Product Change Notification

PCN-PCC-6420-2020

Business Unit	Product Line Code	Type of Change	Action	Date of Issue
PCC - PCB Connectors	AAB	Product Change Notification	Notify Distributors and Field	12/10/2020

Description for Product Change Notification

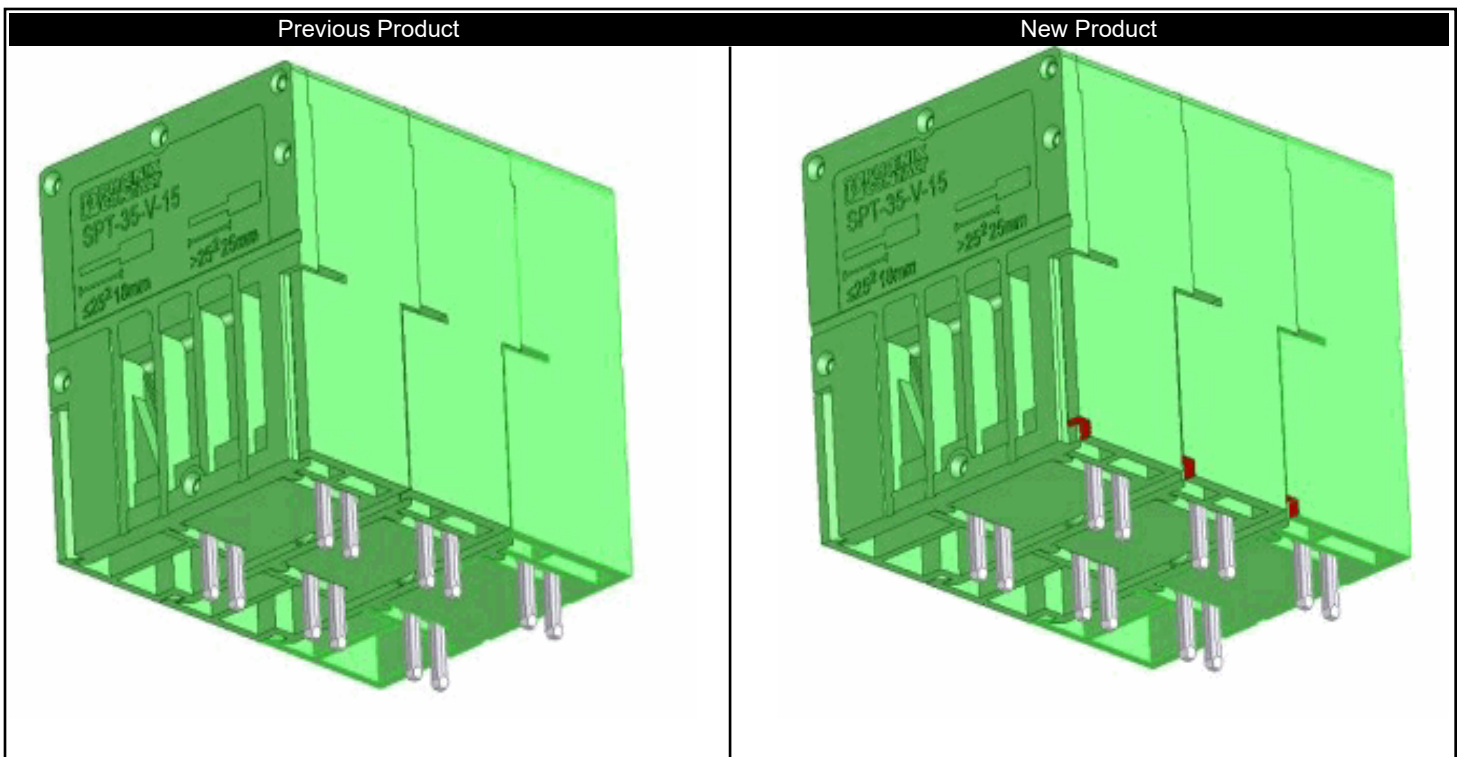
The contour of the SPT 35 terminal blocks is being changed as part of a tool optimization project. A groove of 1.6 x 1.8 mm will be added to the rear side of the terminal block on the lower edge. The overall dimensions of the terminal block remain identical. The PCB layout, the technical performance data, and the terminal block approvals are not affected by this change. The revision level will be changed from 0 to 1. Depending on local inventory both versions may be delivered.
